STAFF RECOMMENDATION
1503 Gartland Avenue
April 18, 2018

Application: New construction – Addition; Partial demolition
District: Lockeland Springs-East End Neighborhood Conservation Zoning Overlay
Council District: 06
Map and Parcel Number: 08309031700
Applicant: Lynn Taylor
Project Lead: Melissa Sajid, melissa.sajid@nashville.gov

Description of Project: Application is to construct side dormers on the historic house and to construct a rear addition that is no taller or wider than the historic house. The application also includes alteration of the existing rear windows on both side façades.

Figure 2: 1957 Sanborn map

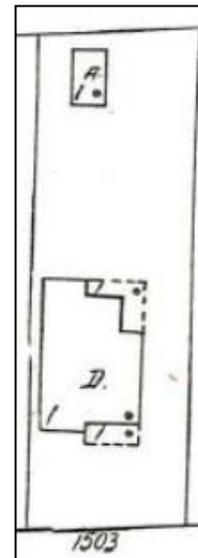
Partial demolition: The demolition plans indicate that the applicant plans to alter the rear windows on both side façades of the historic house. The 1957 Sanborn map shows that there was previously a covered porch that has since been enclosed on the right side façade, so the window on that side that is to be altered is not original to the house (Figure 2). Staff finds that changing both window openings as proposed is appropriate since the windows are near the rear of the house and will not be highly visible from the street. The proposed partial demolition keeps with previous decisions by the Commission to permit alterations of openings that are located at or beyond the midpoint of a historic house. In addition, the applicant proposed to demolish an existing uncovered rear deck that is approximately twelve feet (12') deep and two hundred and sixty-five square feet (265 sq. ft.), which staff finds to be appropriate as it is not original to the historic house. Therefore, staff finds that the demolition of the rear deck and alteration of the windows as proposed meets Section III.B.2. for appropriate demolition and does not meet Section III.B.1. of the design guidelines for inappropriate demolition.

SITE PLAN

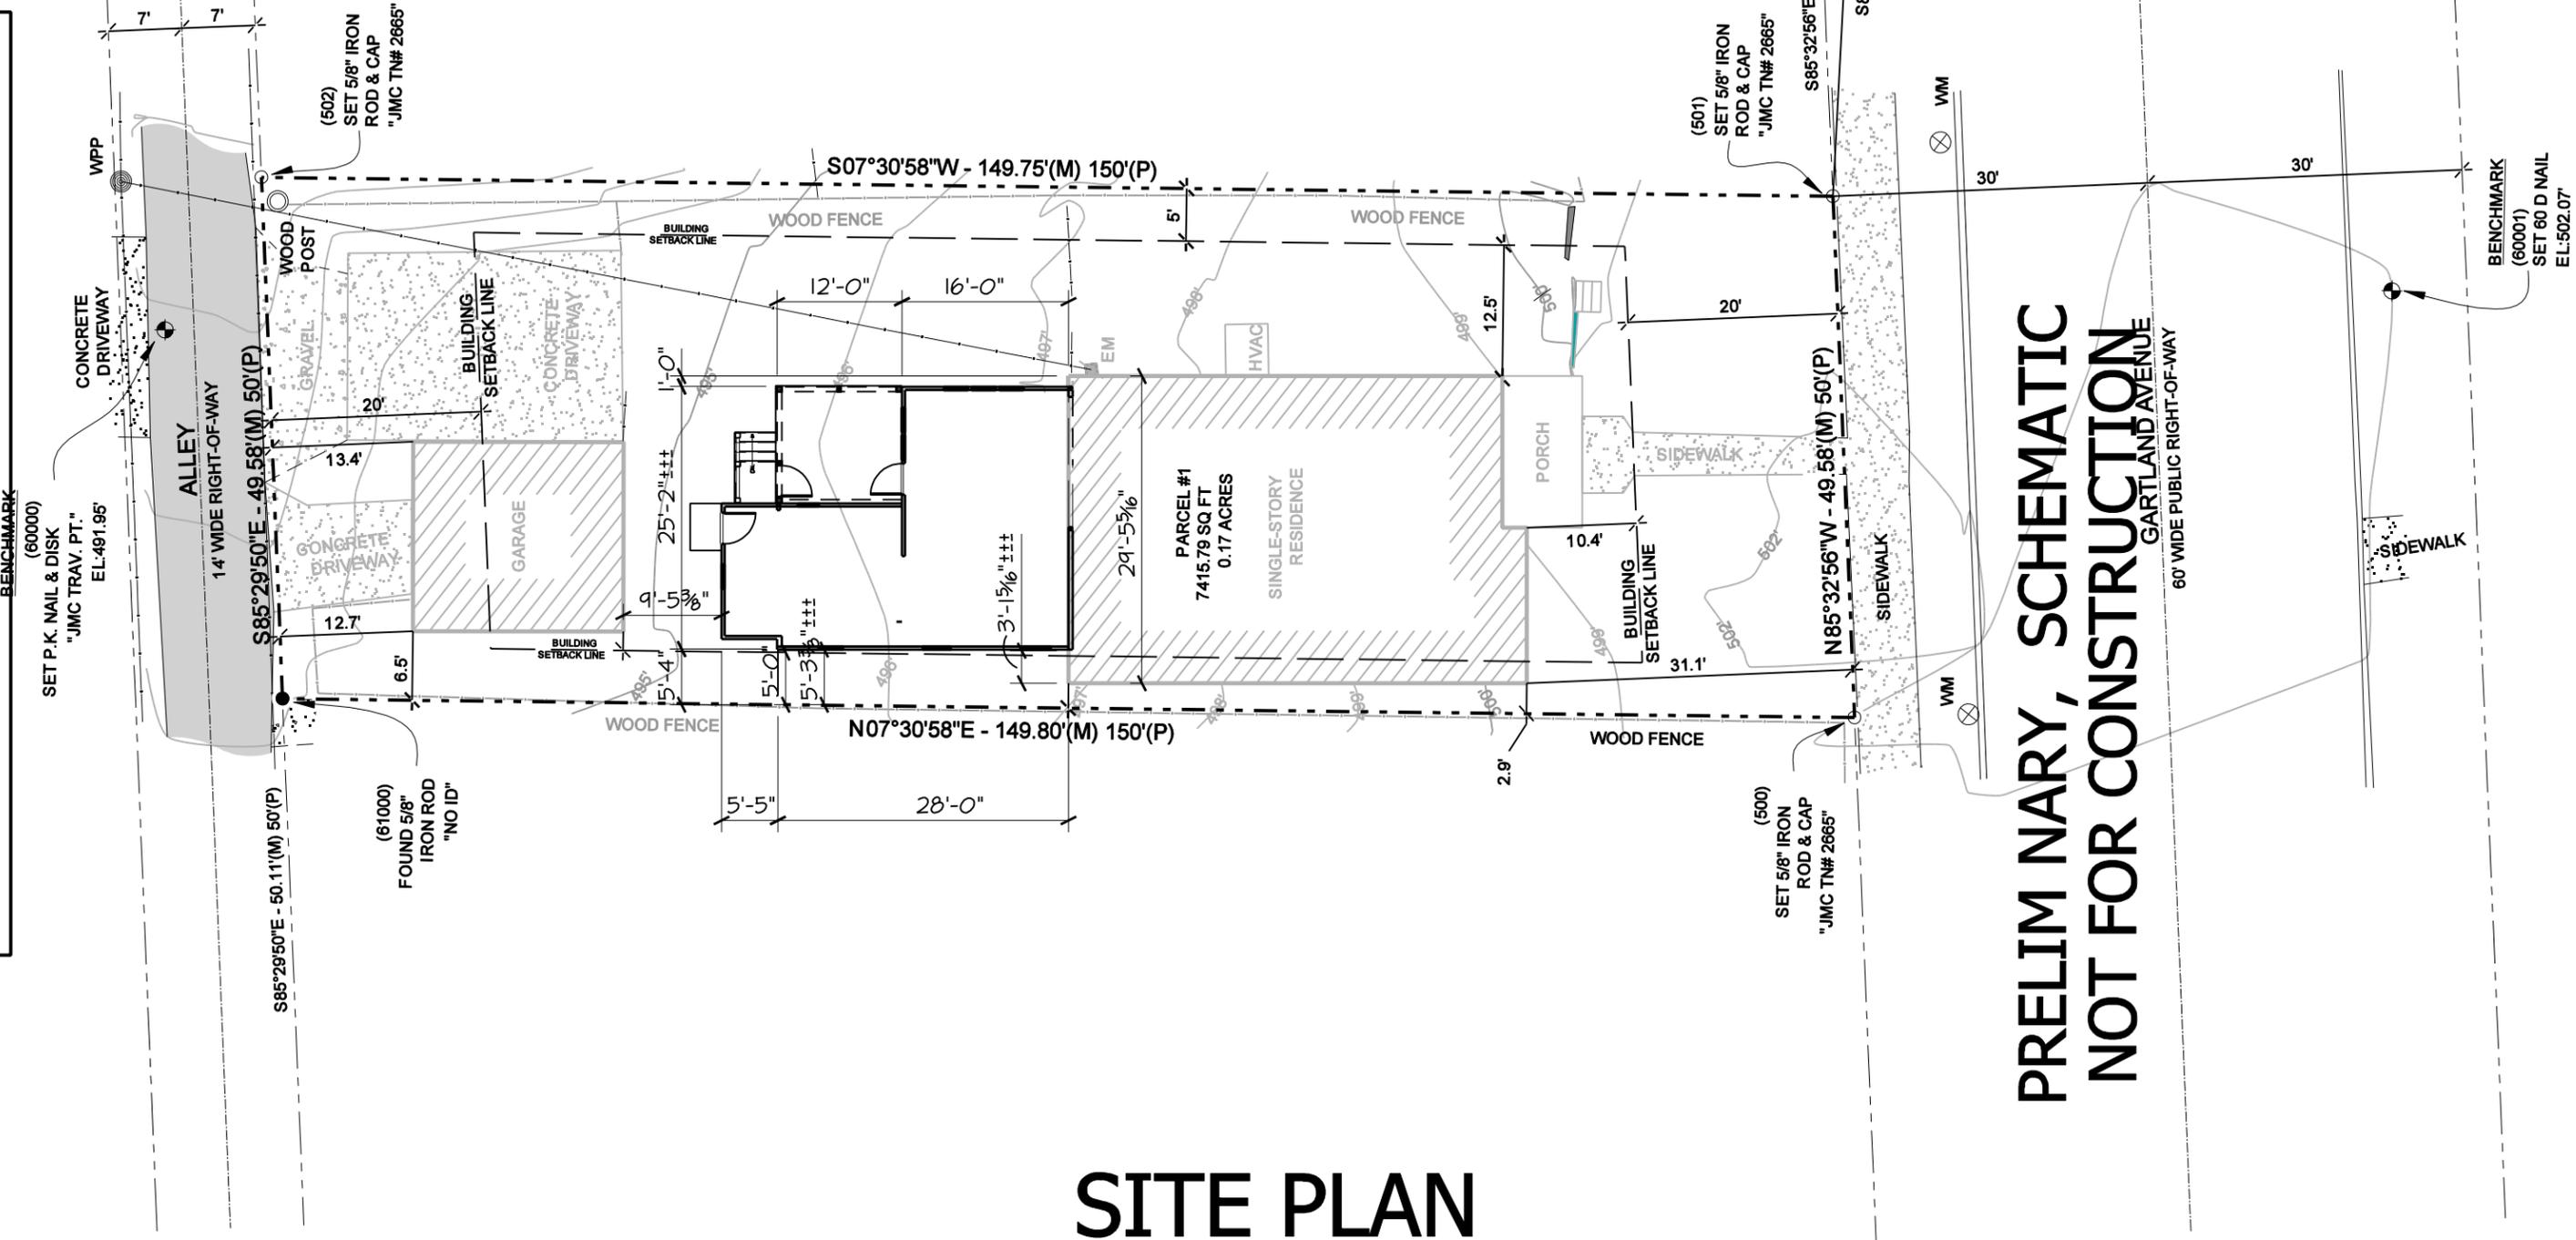
Setback & Rhythm of Spacing: The proposed addition meets all base zoning setbacks. It will be more than five feet (5') from the side property lines and more than forty feet (40') from rear property line. Staff finds that the proposed addition meets Sections II.B.3. of the design guidelines.

LEFT SIDE ELEVATION

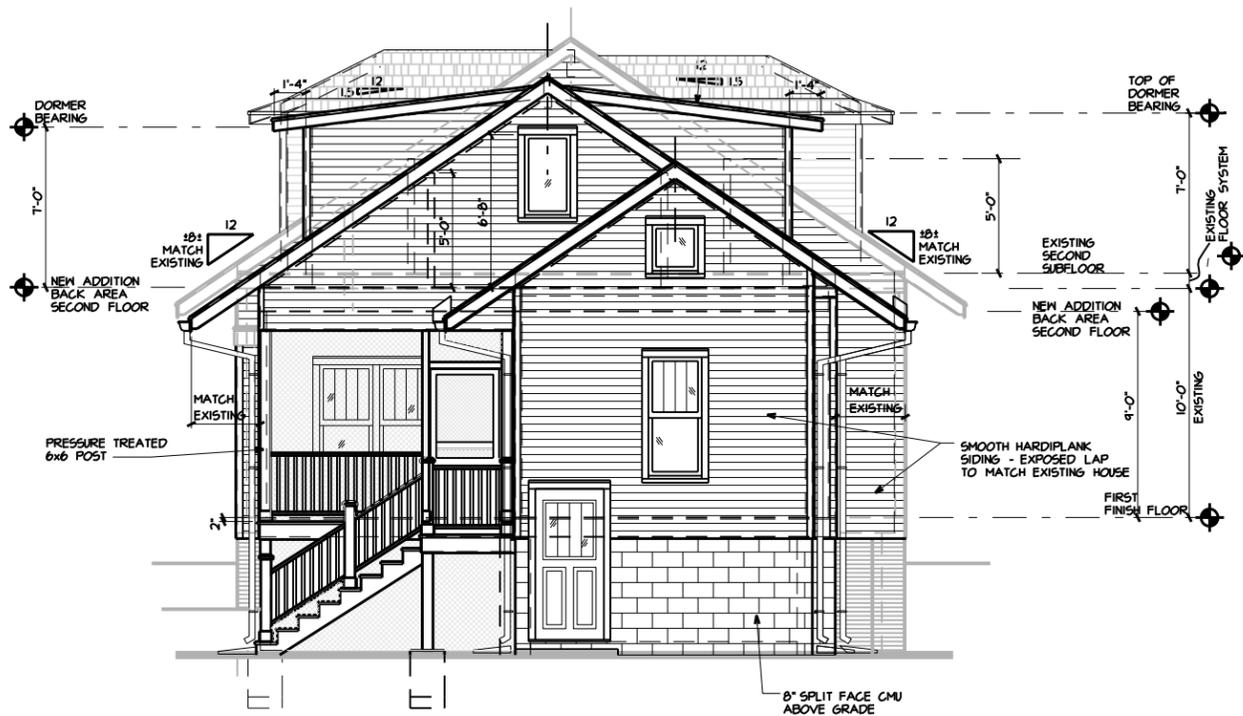
Proportion and Rhythm of Openings: Most of the windows on the rear addition are twice as tall as they are wide, thereby meeting the historic proportions of openings. There are two smaller, square windows located on the left side façade of the addition and one on the rear. Staff finds these windows to be appropriate as they will not likely be visible

The windows in the side dormer addition on the left side elevation of the historic house includes three windows that encompasses a majority of the width of the dormer; however the side dormer addition on the right side elevation only includes a single window. Staff recommends that the side dormer addition on the left side façade incorporate additional glazing. Filling the dormer with windows will help to minimize the perceived width of the dormer and is consistent with previous decisions by the Commission with regard to dormers.

With the condition that the dormer, on the right side façade of the historic house, incorporate additional glazing staff finds the project's proportion and rhythm of openings to meet Section II.B.7.
